# Beam Line

## Addressing Readiness Review Report Recommendations

J. Dunne 8/23/2007

Proposed He bag support structure

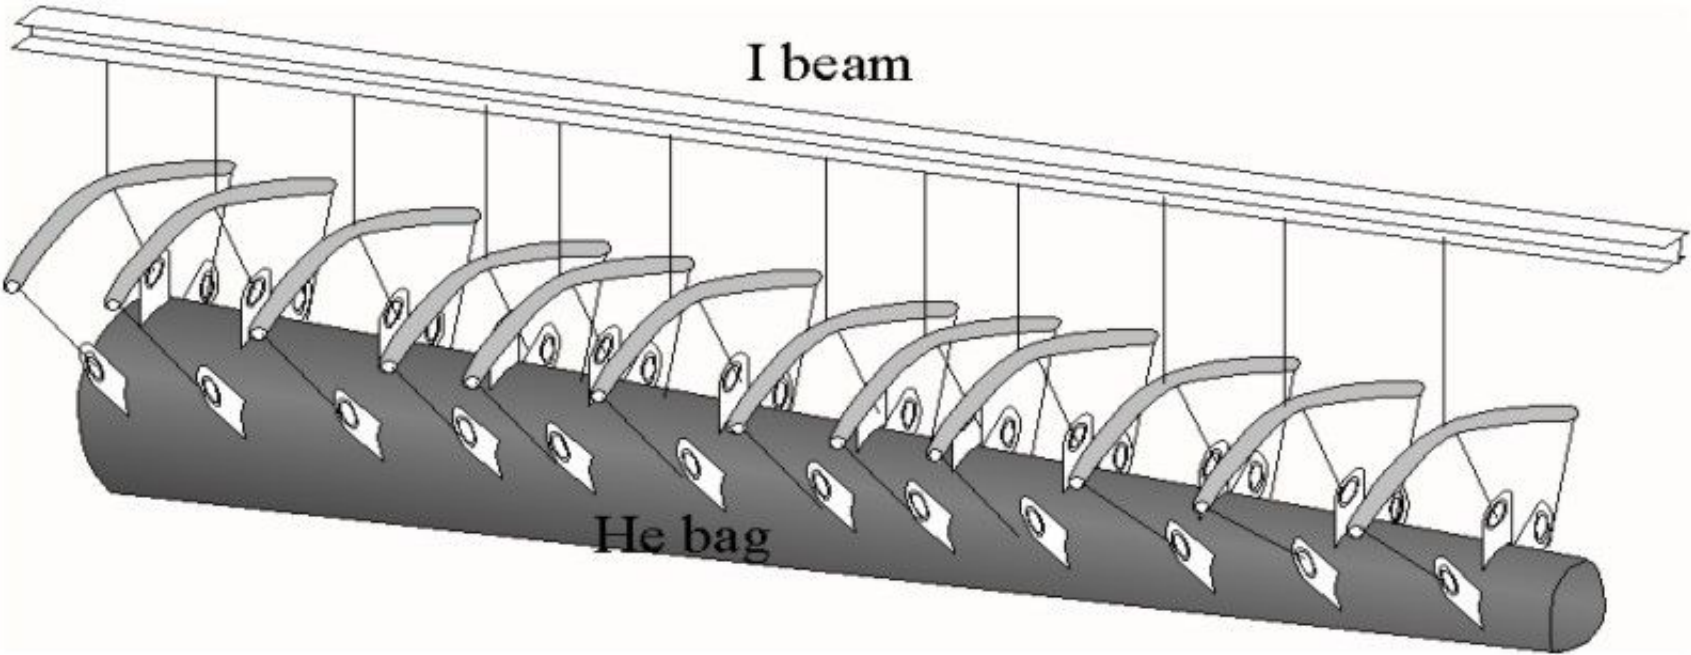
- There should be a low current (nA) diagnostic package of some kind to verify beam position from the target to the dump.

- Longitudinal running – beam dump has ion chambers.
- Transverse running – put ion chambers after He bag.
  - Possibly add cu ring matching downstream window on He bag with ion chambers around
  - Need to determine space between He bag and temporary dump
